PLANS AND DOCUMENTS
referred to in the PDA
DEVELOPMENT APPROVAL

PROJECT TITLE
HAMILTON REACH STAGE 10
RIVERHOMES

Project
HAMILTON REACH STAGE 10
PARKSIDE COURT
NORTHSHORE HAMILTON, QUEENSLAND, 4007

Drawing Title		SITENETWORKS AND STORMWATER DRAINAGE PLAN	
Drawn	Date	Scale	Alt.
N.HOANG	JUNE 2018	1:200	A1
Designed	Project No.	Draw No.	Issue
P.KIRBY	BR180219	C3.01	C

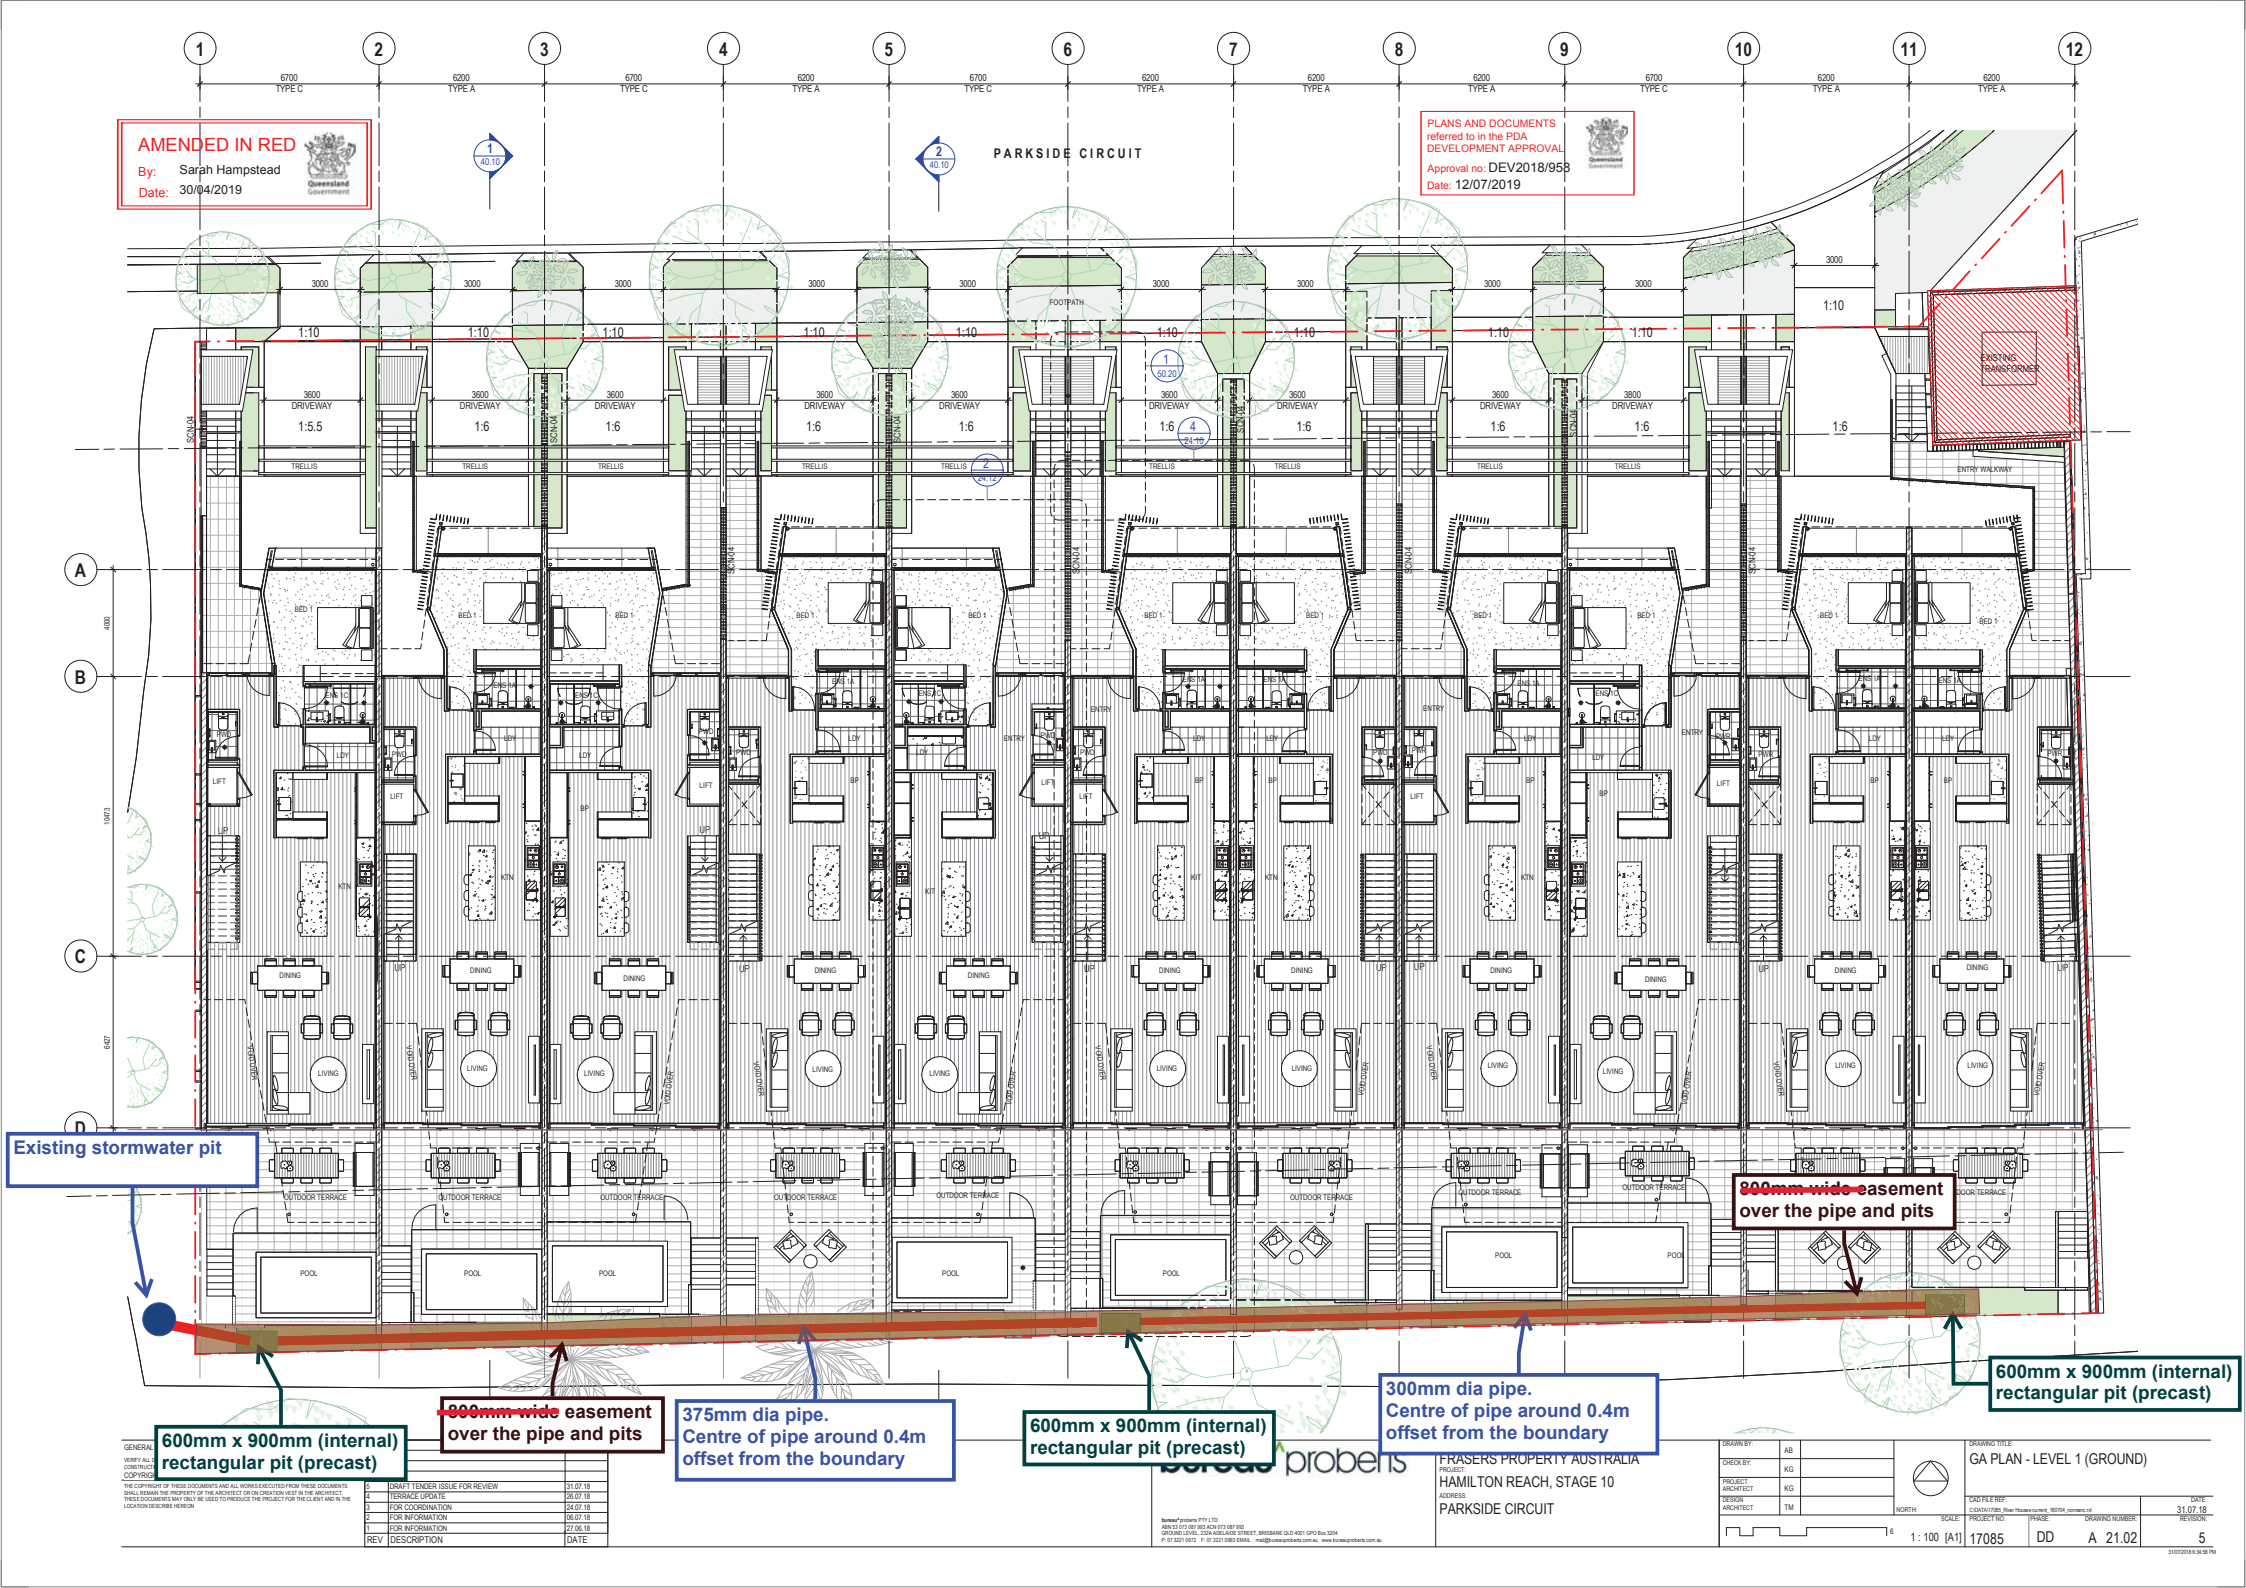
AMENDED IN RED
By: Sarah Hampstead
Date: 30/04/2019

800mm wide easement
over the pipe and pits

600mm x 900mm (internal)
rectangular pit (precast)

800mm wide easement
over the pipe and pits

375mm dia pipe.
Centre of pipe around 0.4m
offset from the boundary

600mm x 900mm (internal)
rectangular pit (precast)

300mm dia pipe.
Centre of pipe around 0.4m
offset from the boundary

600mm x 900mm (internal)
rectangular pit (precast)
